UNITED STATES PATENT AND TRADEMARK OFFICE

APPLICATION NO.	FILING DATE	FIRST NAMED INVENTOR	ATTORNEY DOCKET NO.	CONFIRMATION NO.
09/806,031	03/26/2001	Rabah Arhab	1200.465	3435

Office Action Summary

DETAILED ACTION

Fig. 8

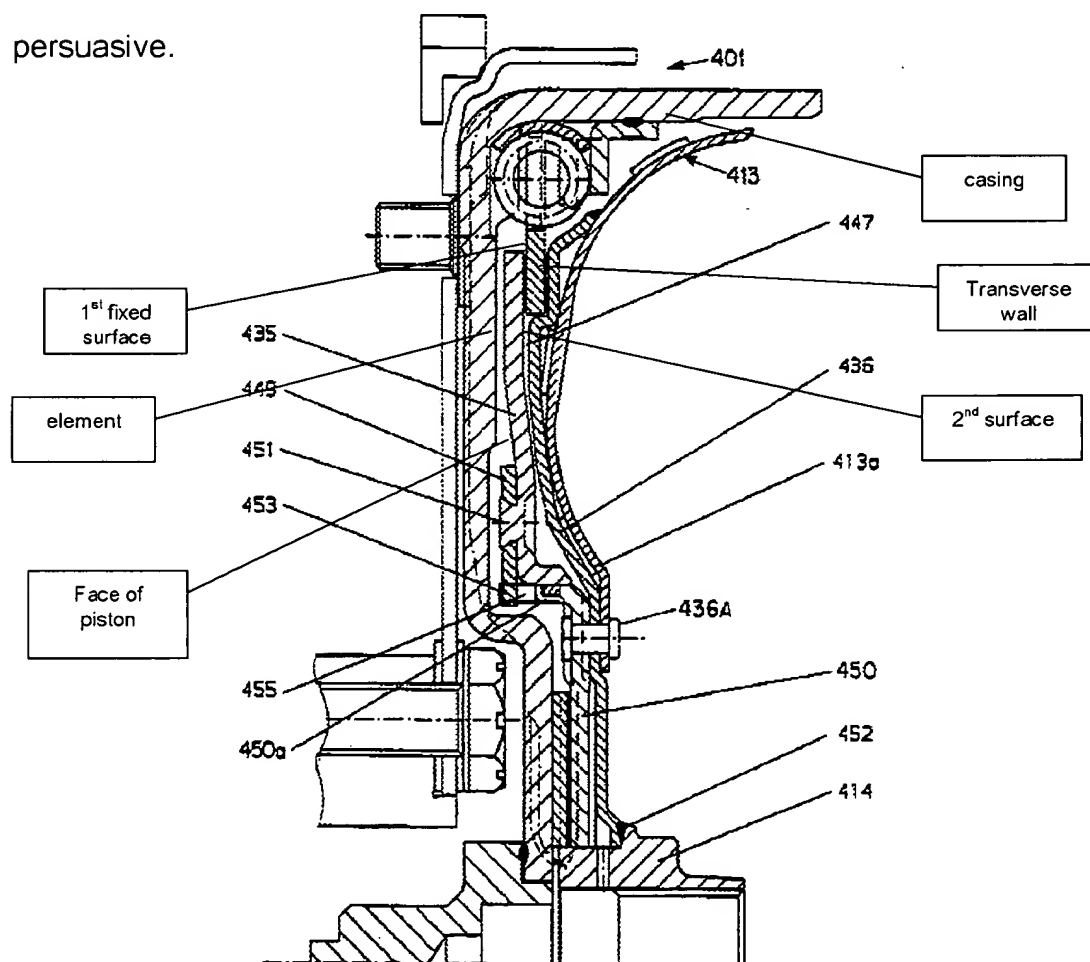
Re: claims 1, 2, 5 and 20. Friedmann et al. show in figure 8 a hydrokinetic coupling apparatus for a motor vehicle comprising a casing as labeled by Examiner in the copy of figure 8 provided in the Response to Arguments section of this Office Action having a transverse wall as labeled and adapted to be coupled in rotation to a driving shaft, a turbine wheel 413 mounted within the casing and fixed to a hub 414,450 which is adapted to be coupled in rotation to a driven shaft, a fixed first surface as labeled on the transverse wall of the casing, and a lock-up clutch as shown interposed between the turbine wheel and the transverse wall and comprising a piston 435 carrying a second surface as labeled which lies facing the first surface capable of coupling it releasably to the transverse wall as the piston reciprocates axially, wherein a friction means 449 acts between a face of the piston as labeled opposed to the second surface and an element situated in facing relationship, characterized in that the piston is so configured as to carry the friction means as shown via element 451.

Re: claims 26, 27, and 28. Friedmann et al. show in figure 8 a hydrokinetic coupling apparatus for a motor vehicle comprising a casing as labeled by Examiner in attached copy of figure 8 having a transverse wall as labeled and adapted to be coupled in rotation to a driving shaft, a turbine wheel 413 mounted within the casing and fixed to a hub 414,450 which is adapted to be coupled in rotation to a driven shaft, a fixed first

surface as labeled on the transverse wall of the casing, and a lock-up clutch as shown interposed between the turbine wheel and the transverse wall and comprising a piston 435 carrying a second surface as labeled which lies facing the first surface capable of coupling it releasably to the transverse wall as the piston reciprocates axially, wherein the turbine wheel 413 includes an annular ring 413a which may be of divided form as best understood and which is fixed to the hub by means of a rivet 436a, and wherein a friction means 449 acts between the hub and the piston, characterized in that the piston is so configured as to carry the friction means as shown via element 451.

As shown in the copy of figure 8 in the previous page, Fiedmann et al. shows a fixed first surface on the transverse wall of the casing, portions of a lock-up clutch shown interposed between the turbine wheel and the transverse wall, the piston carrying a second surface which lies facing the first surface capable of coupling it releasably to the transverse wall as the piston reciprocates axially via element 455 wherein the friction means acts between a face of the piston opposed to the second surface and an element or a second transverse wall of the casing situated in facing relationship. Examiner maintains that, as broadly claimed, element 449 is a friction means as the portions 453 of element 449 are made such that they are free to move in sockets or recesses 455 in which the portions 453 are received. Accordingly, the rejections based on Friedmann et al. are maintained.
